Environmental Assessment Errata Sheet

Loop 375 (Transmountain Road) from I-10 to 0.479 mile East of the Tom Mays Unit of the Franklin Mountains State Park Entrance

CSJ 2552-01-033

August 9, 2011

MATCH LINE D

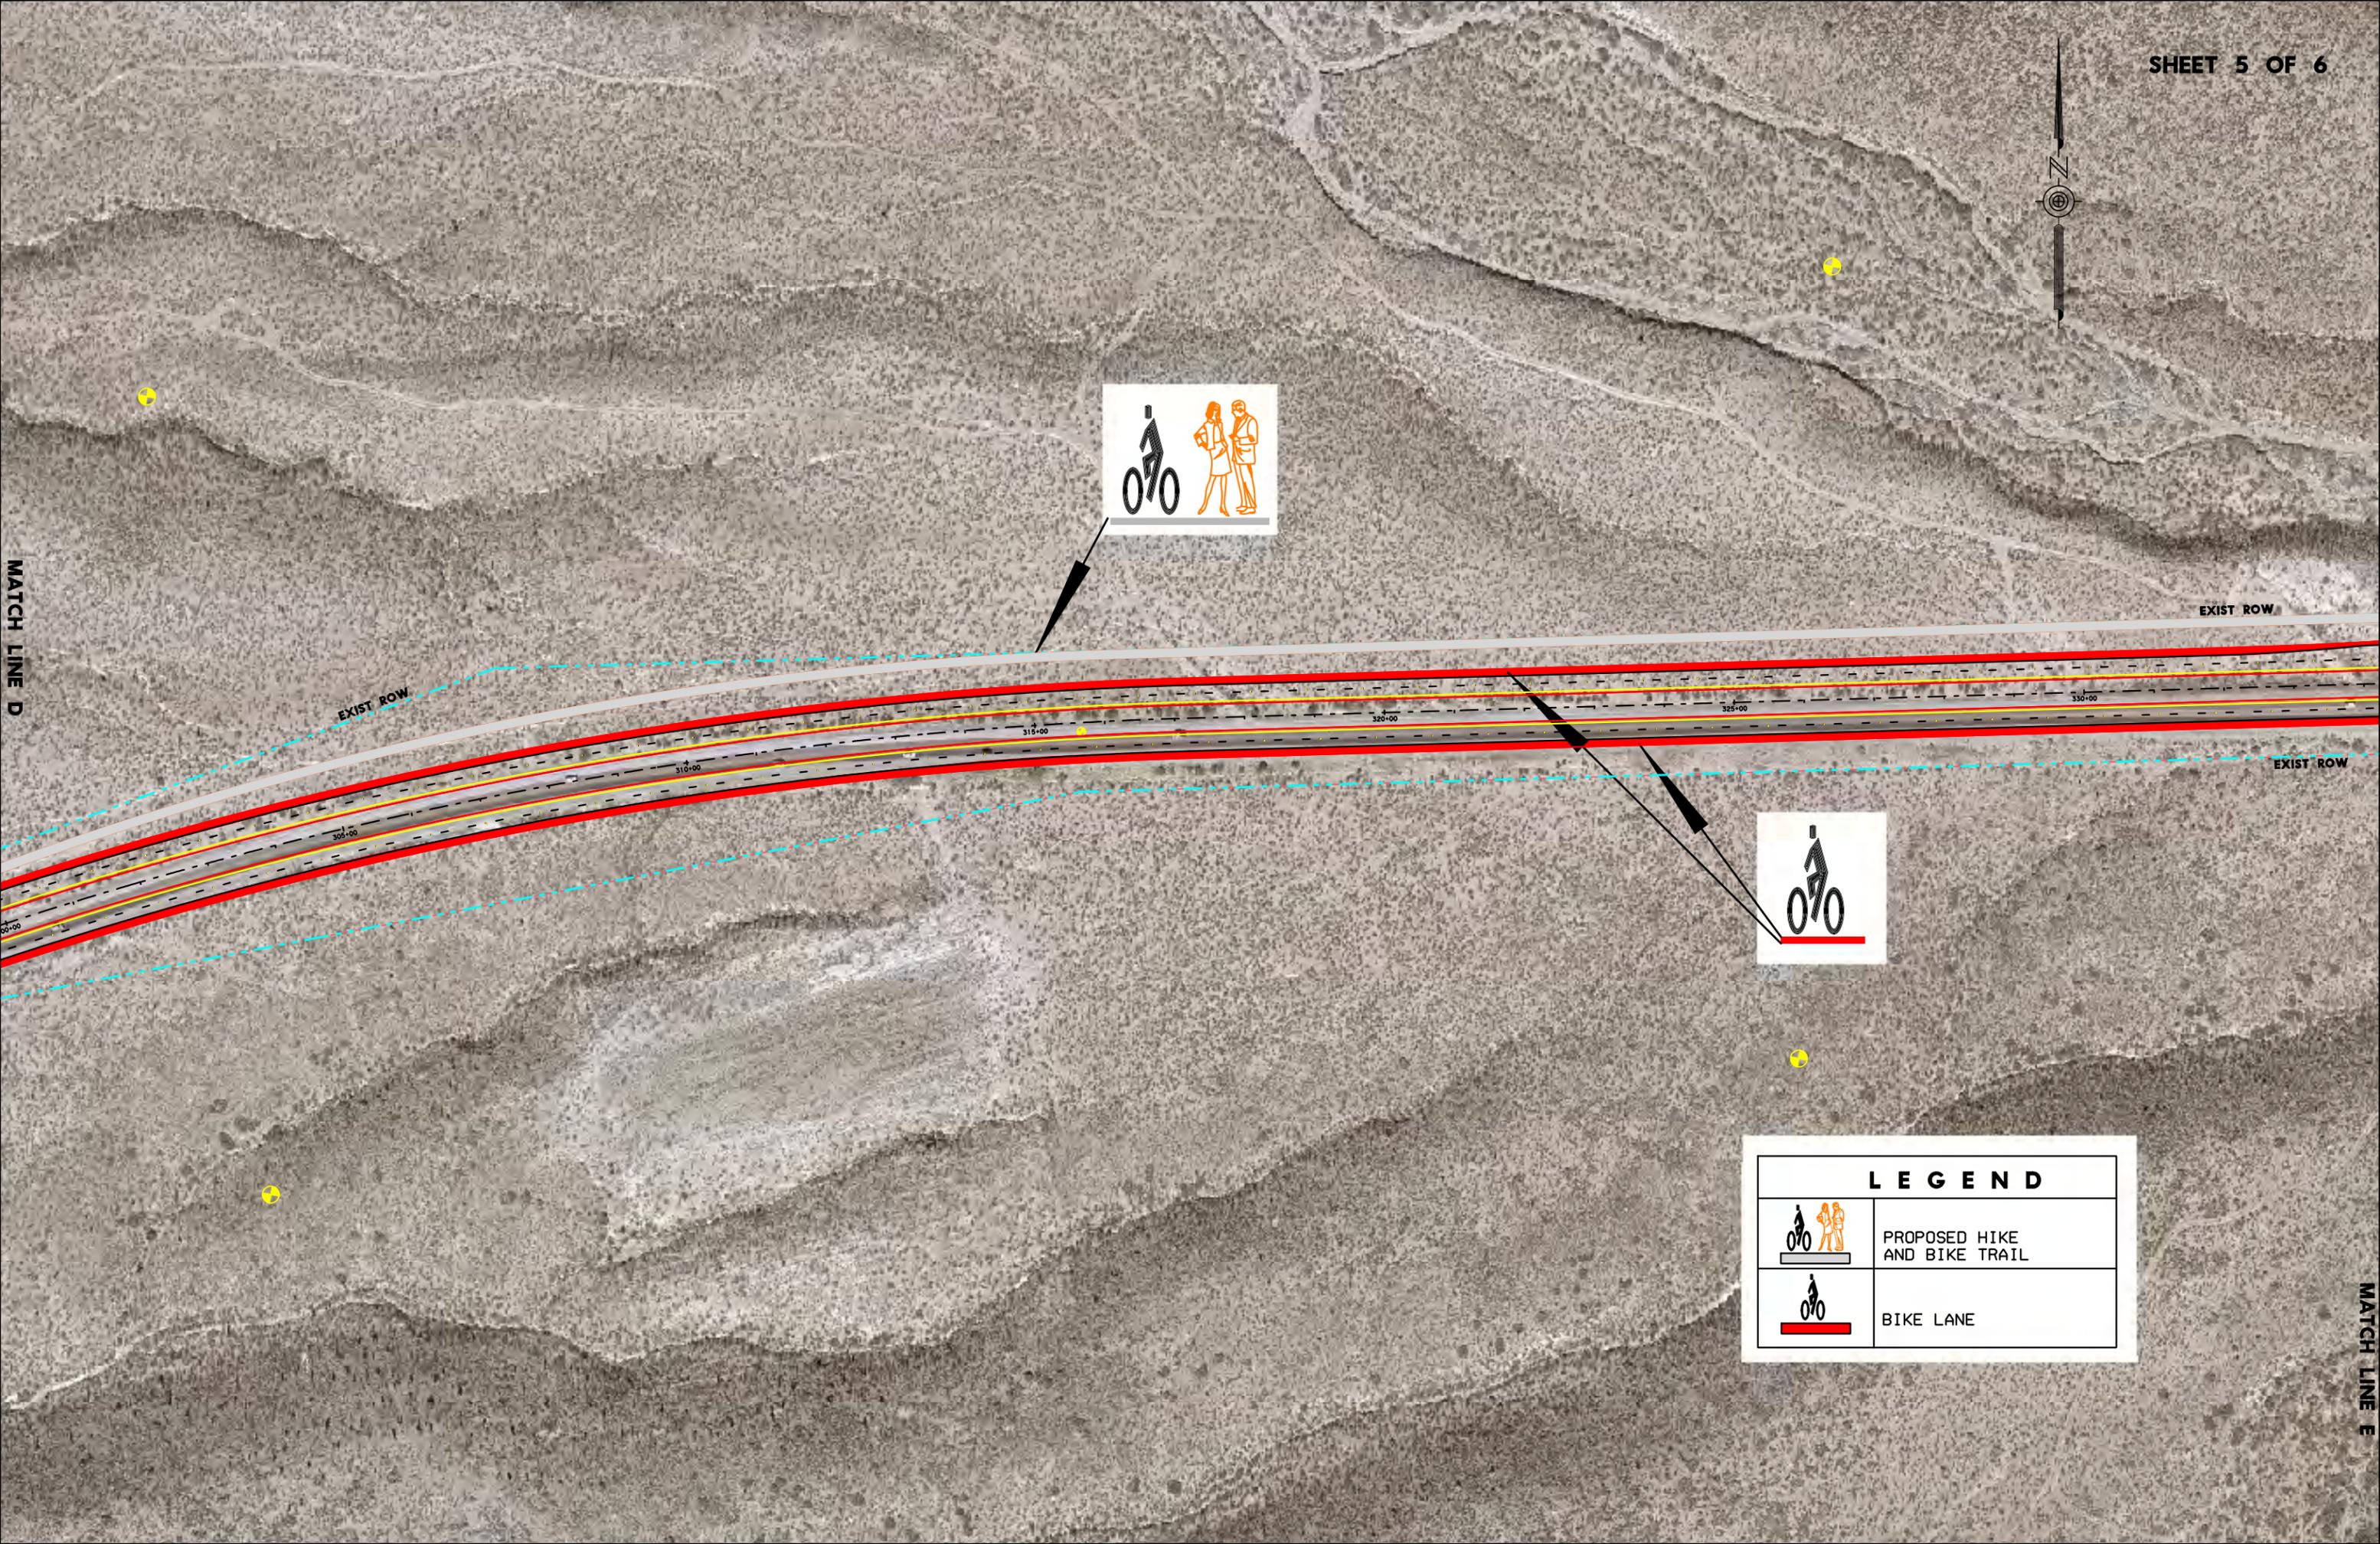
23. Page 119, Section 3.15: the following statement is added as an additional bullet regarding the proposed hike-and-bike trail:

***TPWD Comment 3:** The February 2011 EA (Page 25 and Figure 4.4) retains the south side hike and bike lane terminus at the frontage road. However, the February 2011 EA (Page 25) commits to encouraging foot and bicycle traffic to cross to the north side of Loop 375 at the Paseo Del Norte Road intersection to continue eastbound towards the Franklin Mountains State Park.*

“TxDOT will construct a hike-and-bike trail north of LP 375 inside existing highway right of way from the proposed Paseo Del Norte Drive and the FMSP driveway. This portion of the hike-and-bike trail would connect with the hike-and-bike trails proposed for construction between I 10 and the future Paseo Del Norte Drive. The hike-and-bike trails located between I-10 and the future Paseo Del Norte Drive would have the option to access the highway shoulders of LP 375 east of the future Paseo Del Norte Drive, or to use the proposed hike-and-bike trail along the northerly right of way line of LP 375 to access the driveway to the Tom Mays Unit. Pedestrian and bicycle traffic would be encouraged to cross LP 375 at the Paseo Del Norte Road intersection using sidewalks and five-foot-wide dedicated bicycle lane, and continue eastbound towards the FMSP Entrance on the north side of the road.”

bicycle lane, and continue eastbound towards the FMSP Entrance on the north side of the road. A diagram noting the hike-and-bike trail system planned for the proposed project is attached to this letter for reference.

TxDOT Response to Comment 3: TxDOT recognizes the comment from TPWD and has designed signing for the proposed project to encourage pedestrian and bicycle traffic that uses the southerly hike-and-bike trail to use the northerly hike-and-bike trail in order to access the driveway to the Tom Mays Unit. Bicycle traffic that wishes to proceed eastbound along Loop 375 will continue to have the option to use the eastbound shoulder of Loop 375 east of the future Paseo Del Norte Drive.
